In its August 29<sup>th</sup> application, Enbridge Gas Inc. (EGI) requested Leave To Construct (LTC) for approximately 6 km of NPS 4 XHP steel natural gas pipeline from the Ridge Landfill to the Chatham East Line at the Blenheim North Gate Station. The purpose of the pipeline is to provide pipeline access of landfill generated gas to the EGI system allowing the gas to be sold.

FRPO has reviewed the application and asked a number of interrogatories which generated little information on the project. FRPO respectfully submits that there is little evidence on the record for the Board to approve the Leave to Construct in the public interest, in spite of the fact that the proponent has committed to pay for the entire cost of the project. In our view, EGI has not provided evidence that demonstrates that its approach to this project facilitates access of RNG producers.

Map of Existing Chatham-Kent Pipeline Network  
Chatham-Kent Rural Project

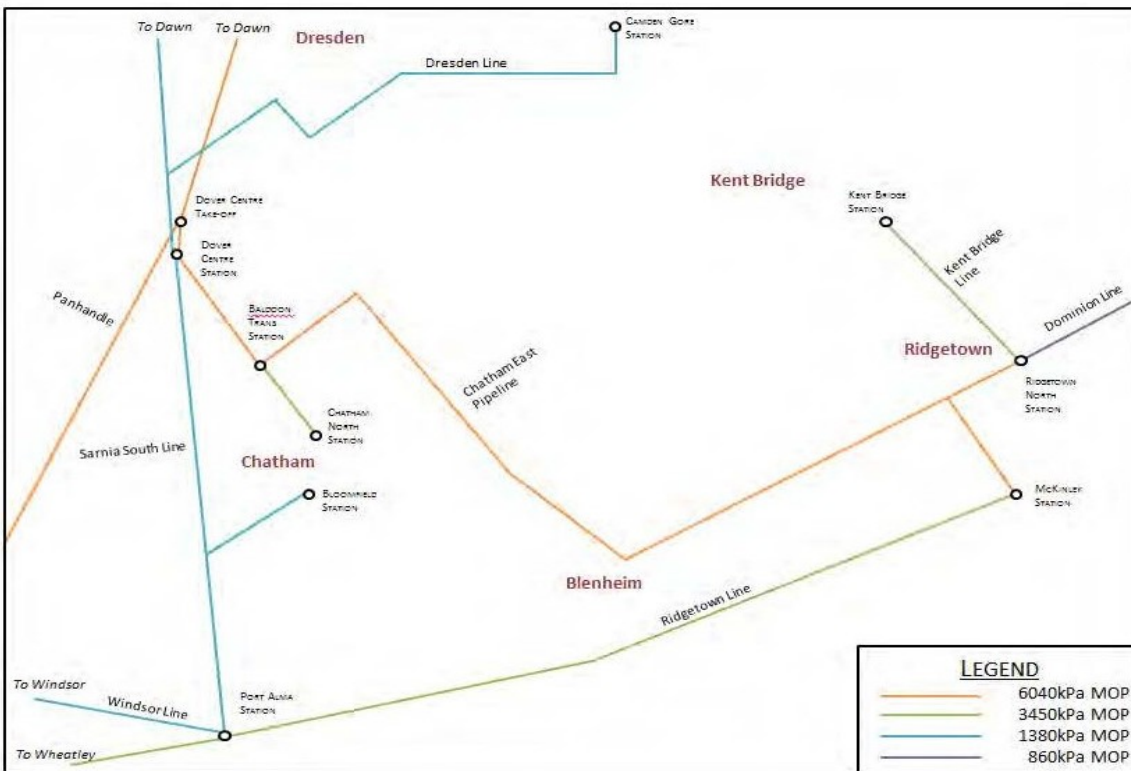
EGI provided, “This is because the map contains specific locations of Company critical infrastructure that poses both a safety and a security risk.” This rationale frankly surprised us as pipeline network maps have been provided by the company on the public record in past facilities applications either in evidence or in response to discovery. Upon receiving a copy of the map after filing our Confidentiality Undertaking, we found that the map was not only very limited in detail but also added terrain to the background which was unnecessary and potentially the source of EGI's concerns over risk.

FRPO had sought the map in conjunction with our questions on alternatives assessed. We believed that the location of pipes in proximity to the landfill would orient ourselves and the Board in understanding the alternatives evaluated. Having received the Board's decision to accept EGI's request for confidentiality, we sought another map filed by EGI recently to provide a frame of reference for the Board in reading our submissions. We found such a map,<sup>1</sup> similar to what we sought in our interrogatory, in a recent LTC application. We have included the map below, embedded in our submissions, to assist the reader in our hearing our submissions in context.

Since the map is not to scale, we did not attempt to situate the Ridge Landfill on the map. However, transposing its location from the confidential map, and with Google Maps as a reference, the Landfill would be approximately just left of the “B” in Blenheim. We used other tools which we will detail later to approximate distances.

First, the scale of the map made it very difficult to understand where these pipes were actually located. Frankly, by knowing the general area, one, including FRPO, could simply go to Google Maps Street view and find the pipeline markers to know the precise location. This information is clearly in the public realm and the confidential treatment of a high-level map, in our view, provides no protection - only additional work for those seeking understanding.

If EGI simply provided a map such as the Map of Existing Chatham-Kent Pipeline Network, the Board and intervenors would be duly informed. The Board needs this type of information to assess the utility's planning.
